ADDENDUM NO. 1

Project: Nebraska Department of Roads – Grand Island Salt Storage Building

Issued: July 31, 2012

J10	TYP. COLUMN CORNER BRACE
SCALE 1 1/2"=1'-0"	(3 REQ'D @ EA. CORNER)

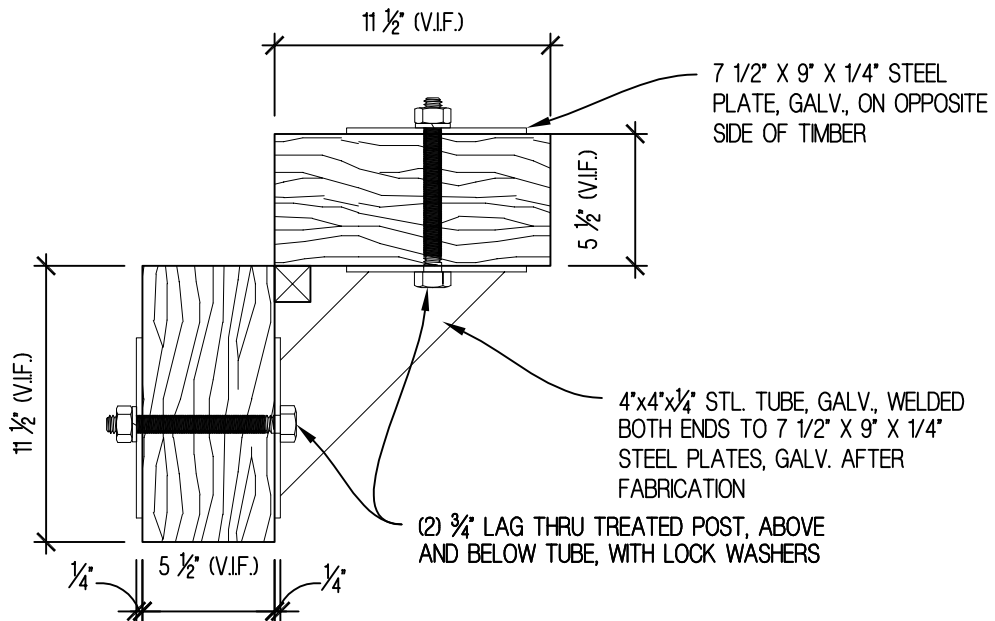
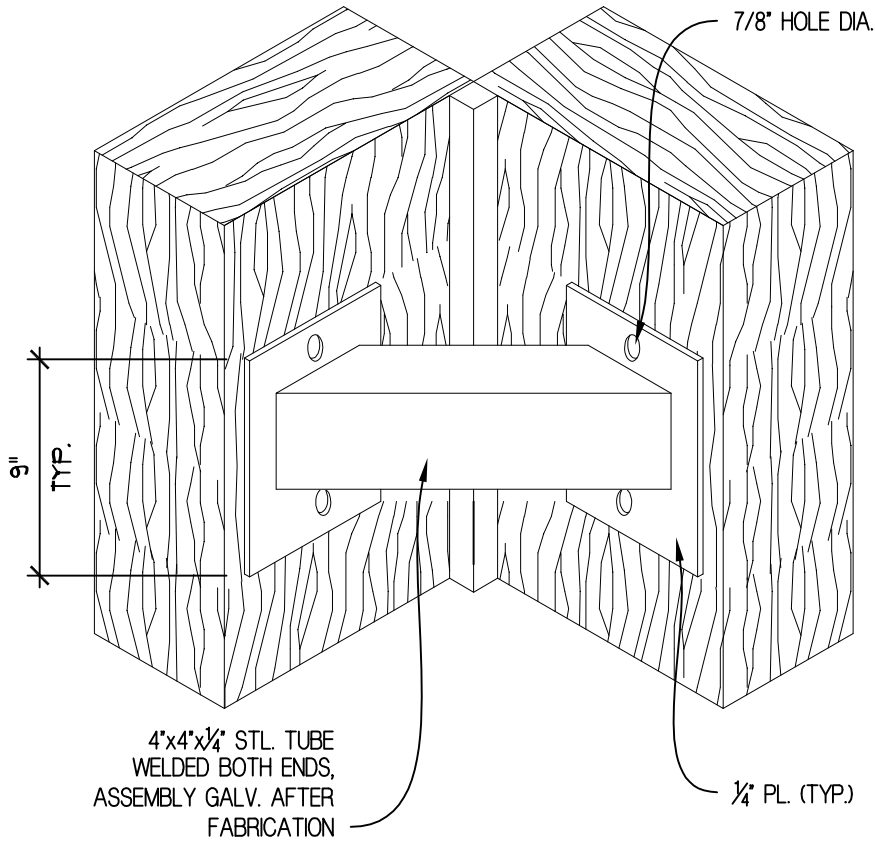
AD1.7. Clarification: All 6x12 treated posts, including door header beams, are supplied by Owner, even where not noted as such.

1. VERIFY TIMBER SIZE PRIOR TO BRACKET FABRICATION
2. GALVANIZE BRACKETS AFTER FABRICATION.
3. ALL POSTS PROVIDED BY OWNER
